Economic Commission for Europe

UN Regulation No. 16 (Safety-belts)

Proposal for the 10 Series of Amendments to UN Regulation No. 16 (Safety-belts)

Submitted by the Ad hoc Group on splitting UN Regulation No. 16 (Safety-belts)*

2. ~~Arrangements of the vehicle approval marks concerning the installation of safety belts~~

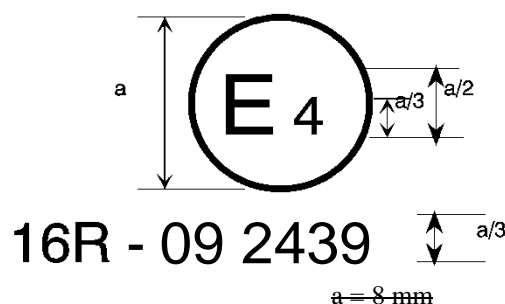
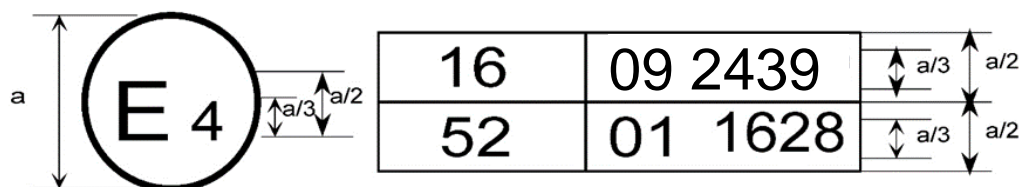
Annex 2, amend to read:

- 2- 1. Arrangements of the safety-belt approval marks (see paragraph 5.32.5. of this Regulation)

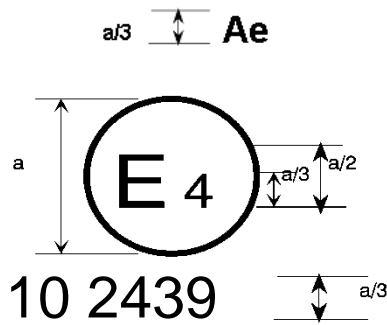
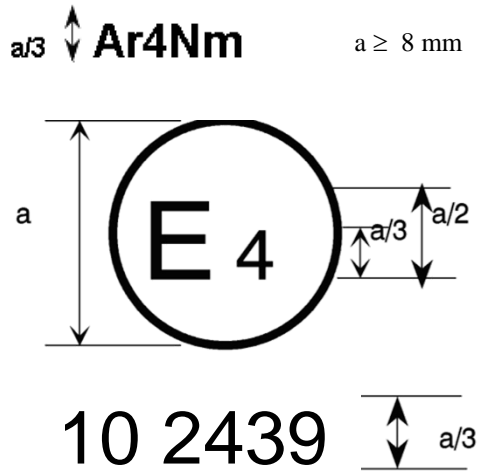
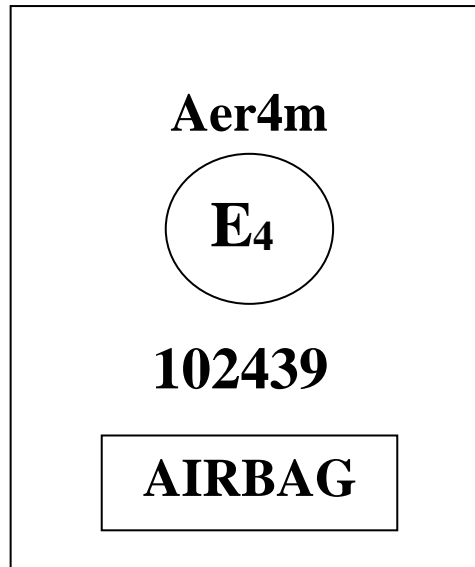
The belt bearing the above approval mark is a three-point belt (“A”), fitted with an energy absorber (“e”) and approved in the Netherlands (E 4) under the number ~~09~~102439, this Regulation already incorporating the ~~06, 07, 08 or 09~~ 10 series of amendments at the time of approval.

The belt bearing the above approval mark is a lap belt (“B”), fitted with a retractor, type 4, with multiple sensitivity (m) and approved in the Netherlands (E 4) under the number ~~09~~102489, this Regulation already incorporating the ~~06, 07, 08 or 09~~ 10 series of amendments at the time of approval.

The belt bearing the above approval mark is a special type belt (“S”), fitted with an energy absorber (“e”) and approved in the Netherlands (E 4) under the number ~~09~~1022439, this Regulation already incorporating the ~~06, 07, 08 or 09~~ 10 series of amendments at the time of approval.

The belt bearing the above approval mark is part of a restraint system (“Z”), it is a special type belt (“S”) fitted with an energy absorber (“e”). It has been approved in the Netherlands (E 4) under the number ~~09~~1024391, this Regulation already incorporating the ~~06, 07, 08 or 09~~ 10 series of amendments at the time of approval.

The safety-belt bearing this type approval mark is a three-point belt (“A”) fitted with an energy absorber (“e”), approved as meeting the specific requirements of paragraph 6.4.1.3.3. or 6.4.1.3.4. of this Regulation, and with a multiple-sensitivity (“m”) type 4 (“r4”) retractor, in respect of which type approval was granted in the Netherlands (“E 4”) under the approval number ~~09~~**102439**. The first two digits indicate that the Regulation already incorporated the ~~06, 07, 08 or 09~~ **10** series of amendments at the time of the approval. This safety-belt has to be fitted to a vehicle equipped with an airbag in the given seating position.
